DEVIATION REQUEST AND DECISION FORM

Project Name : HAVEN VALLEY
 Schedule No.(s) : 6512200001
 Legal Description : ELY 780 FT OF N2NW4NW4 SEC 12-15-66

DEVIATION REQUEST (Attach diagrams, figures, and other documentation to clarify request)

TYPICAL PRIVATE STREET SECTION
(URBAN LOCAL-LOW VOLUME)

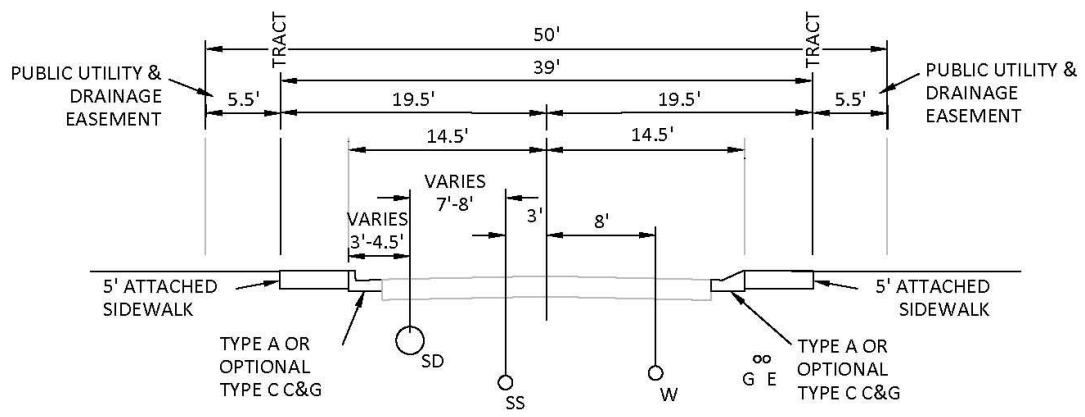
Detail SD_4-1 Urban Local Roadway Utility Placement Cross Section – specifically, 6' distance from center of storm drain to top back of curb.

This deviation is a request for approval of a 3'-4.5' distance between center of storm drain to top back of curb within this project site. The cross section for the roadways is 29' from top back of curb to top back of curb. The water line has been placed 4'-4.5' from the center to the lip of gutter. The sanitary line has been placed 11' from the center of the water to the center of the sanitary line. The storm has been placed 7'-8' from the center of the sanitary to the center of the storm. This leaves 0.5'-2' from the center of the storm to the lip of gutter.

The proposed streets and storm sewer within this project site are private and it will be the responsibility of the HOA to maintain the roads and curb. The HOA will also be responsible for replacing any damaged curb & gutter resulting from their decision to place the storm drain with less separation from the curb. The ECM standard is 6' from center of storm drain to top back of curb. The proposed alternative is 3'-4.5' from center of storm drain to top back of curb.

These are private roadways. Any maintenance needed as a result of storm drain placement will be the responsibility of the HOA. The water and sanitation district requires 4' from the outside of the waterline to the lip of gutter and 10' from the outside of the water to the outside of the sanitary sewer line.
